ADDENDUM NO. 2

Issued by: Sacramento City Unified School District

Project: Project #: 0029-401 Bret Harte Playground

| DSA STAMP | | | |
|---|---|-----------|--|
| Date 01/24/2023 Scale AS SHOWN Drawn Checked AT AT | Project Number 22035 Drawing Number C4. | _ | |

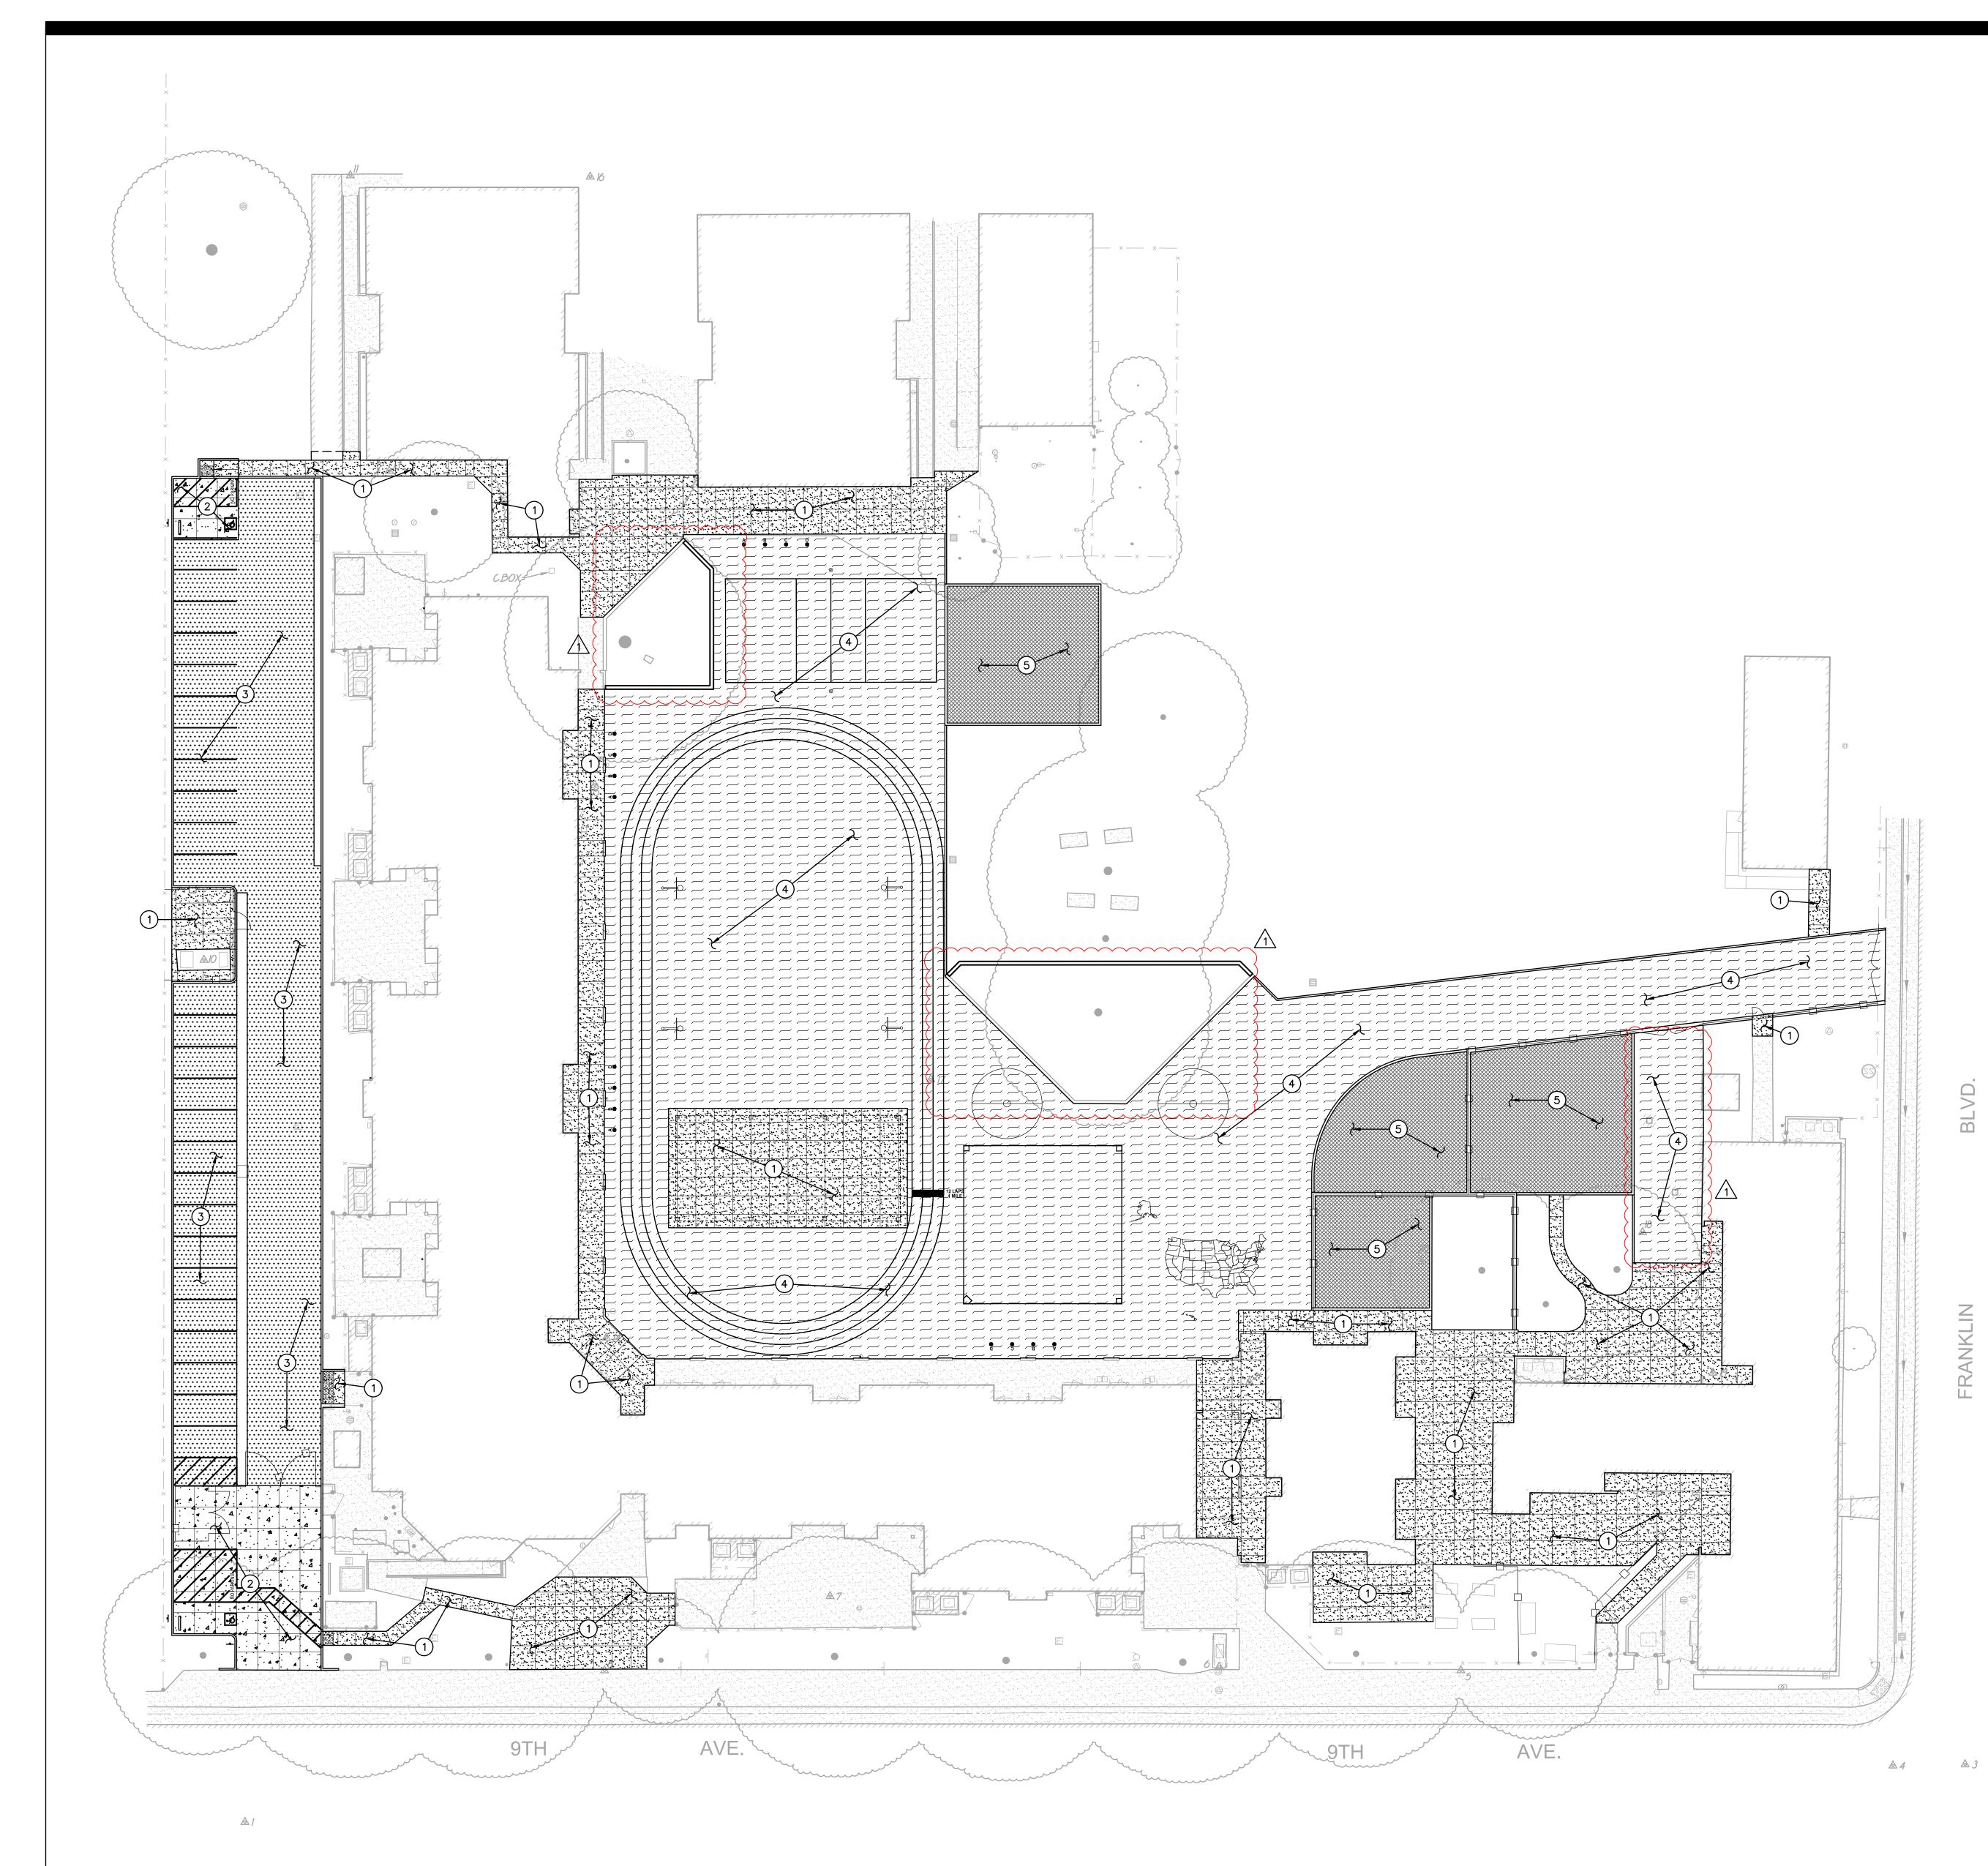
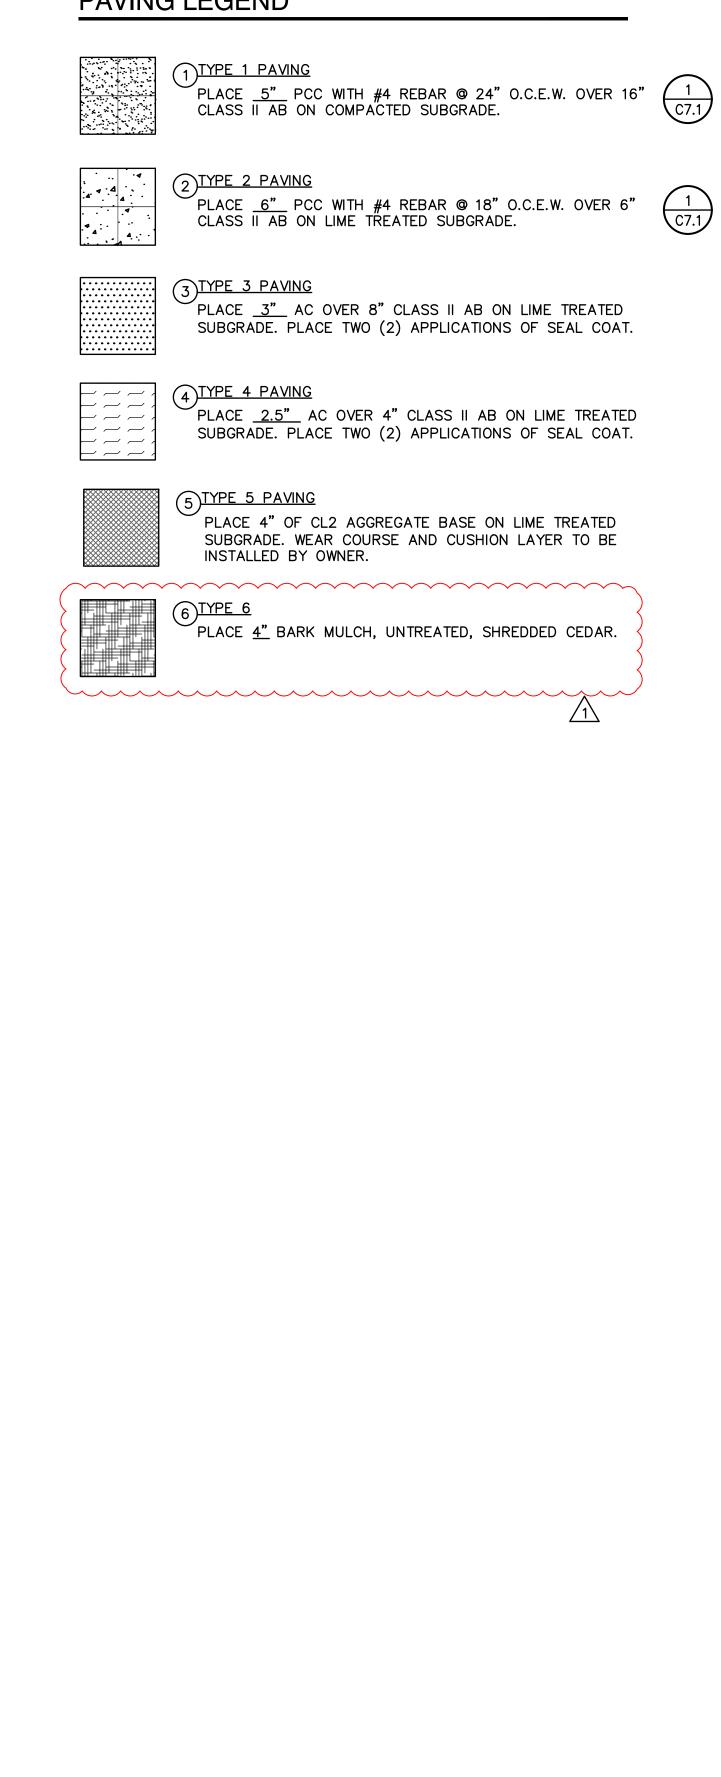
- J. SHEET C4.1:
 - 1. Remove mulch at (2) planters
 - 2. Add AC paving to area adjacent to shed
- K. SHEET C5.1:
 - 1. Add details 5, 6 and 7 to sheet
 - 2. Notes 21, 22, 23 and 24 added to Playcourt Striping Notes

| DSA STAMP | | |
|---|--|--|
| Date 01/24/2023 Scale AS SHOWN Drawn Checked AT AT | Project Number 22035 Drawing Number C5.1 | |

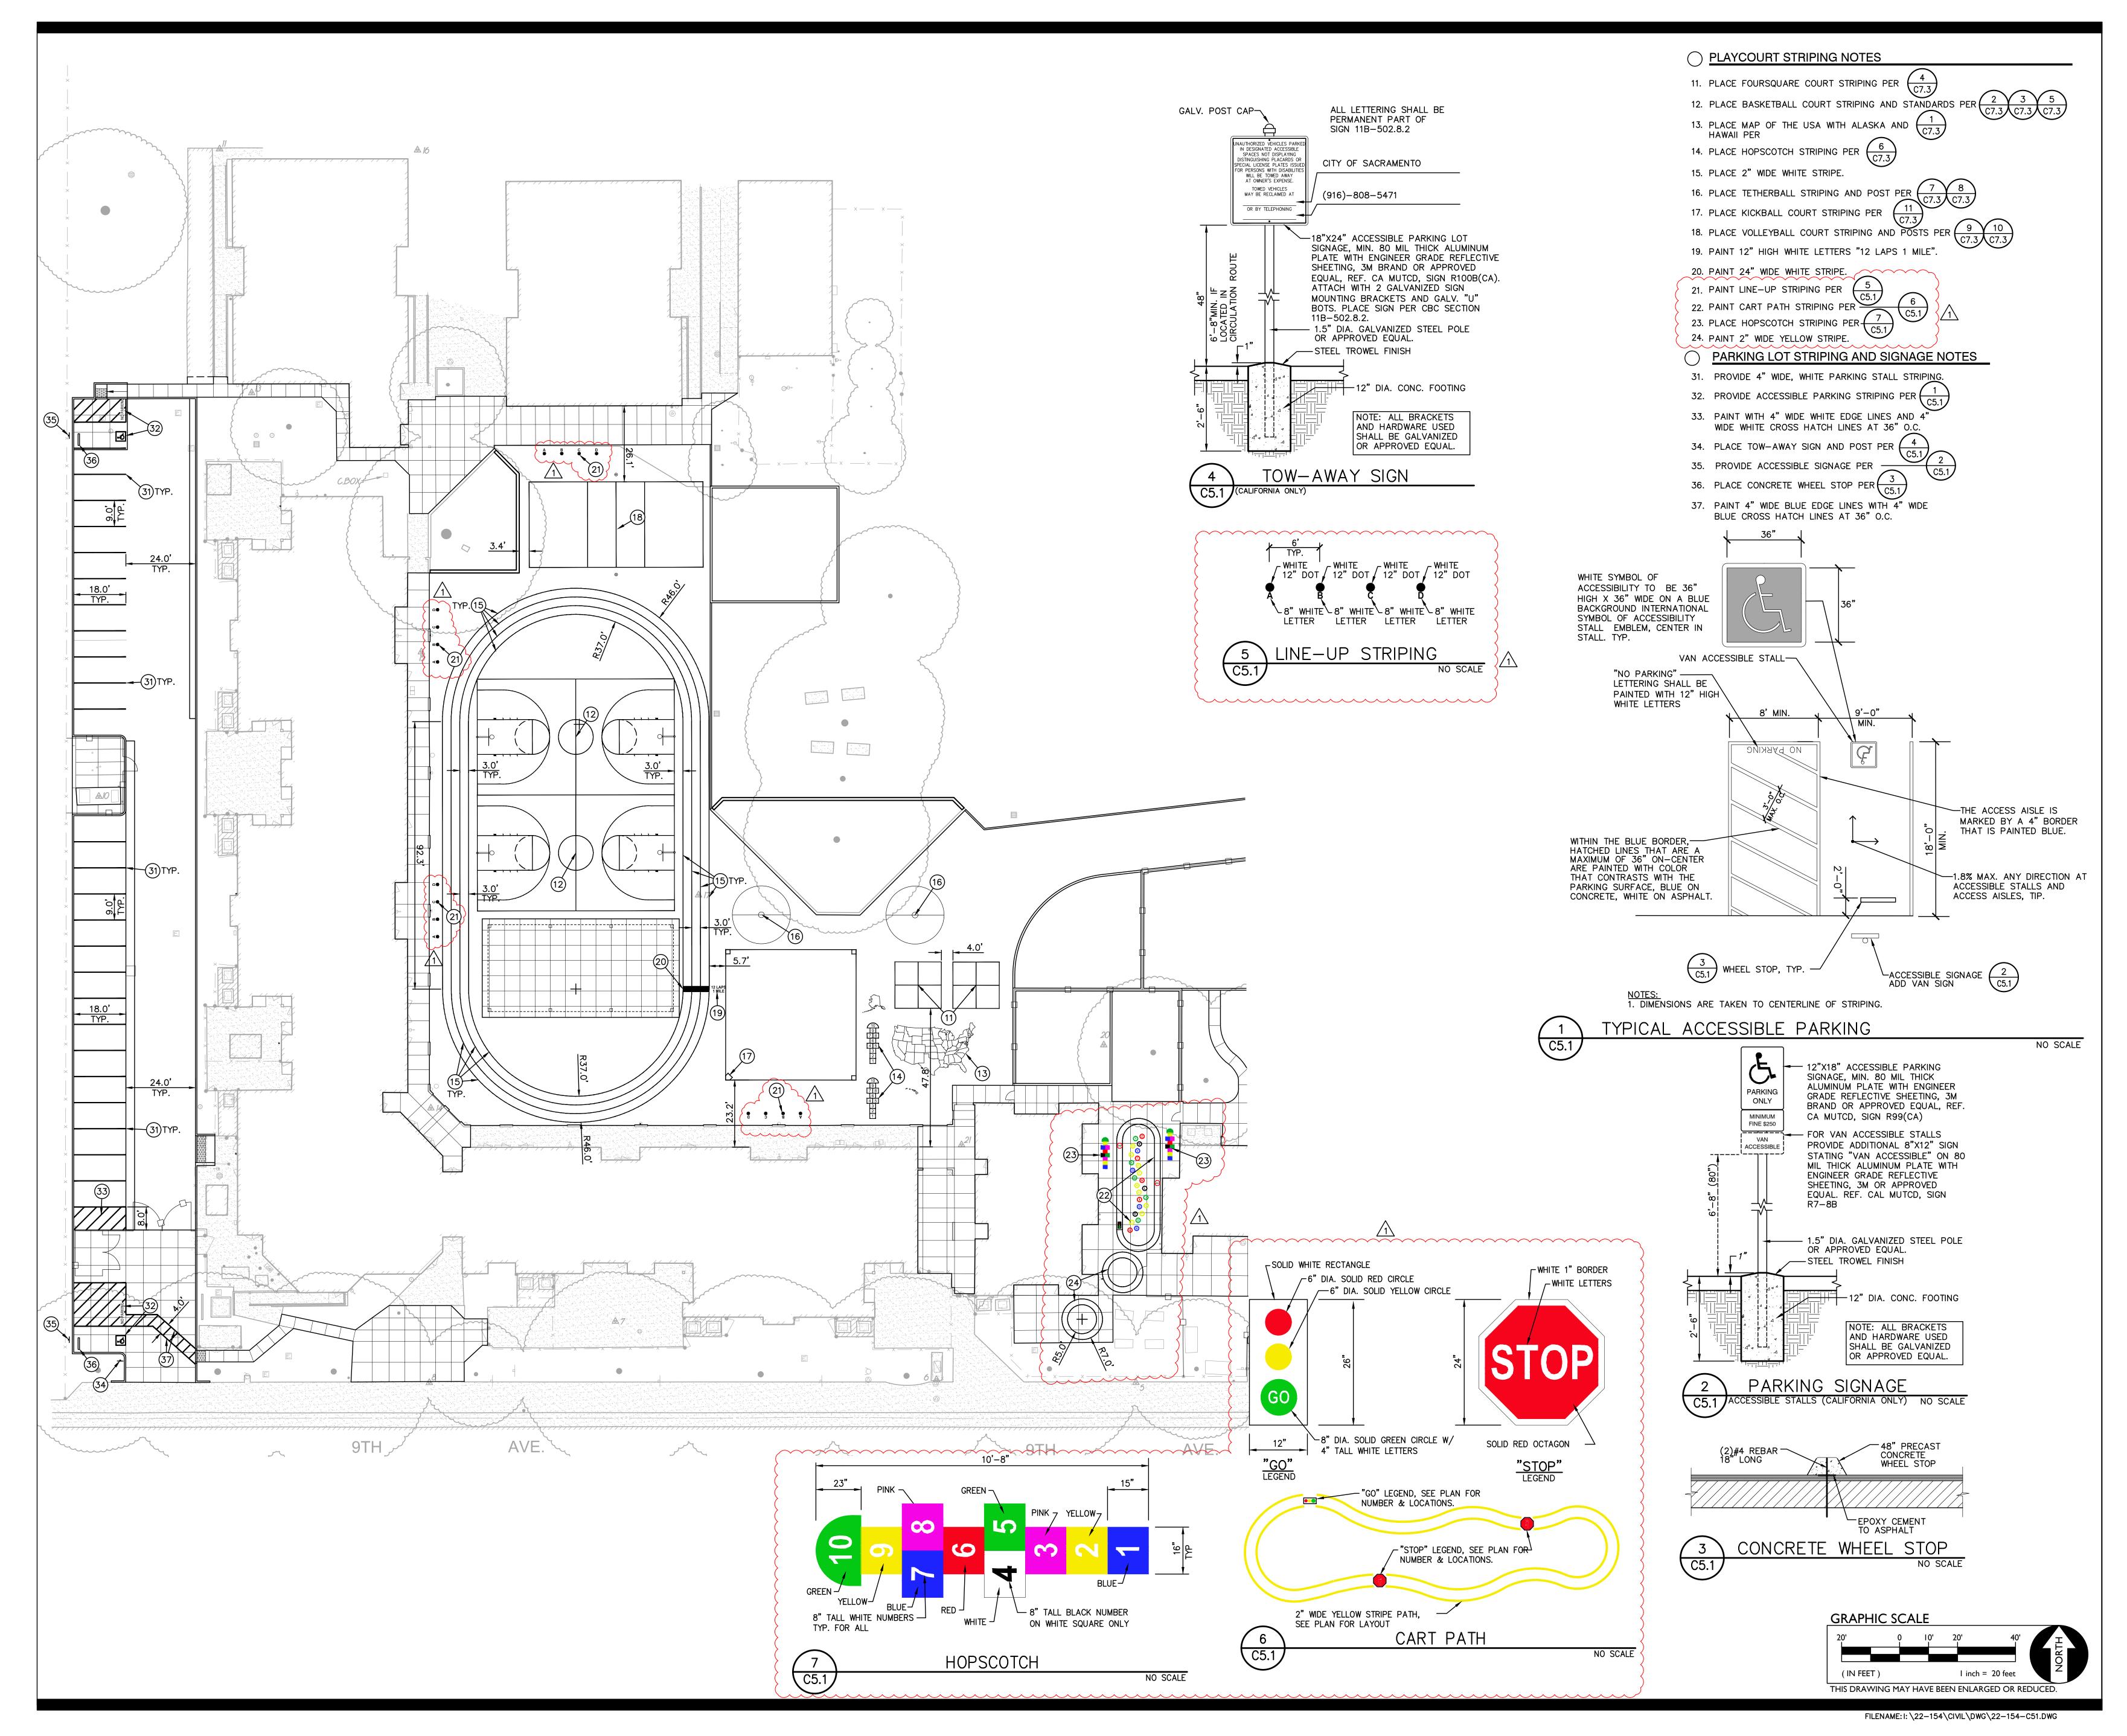
- 3. Dots added to north and east of new track
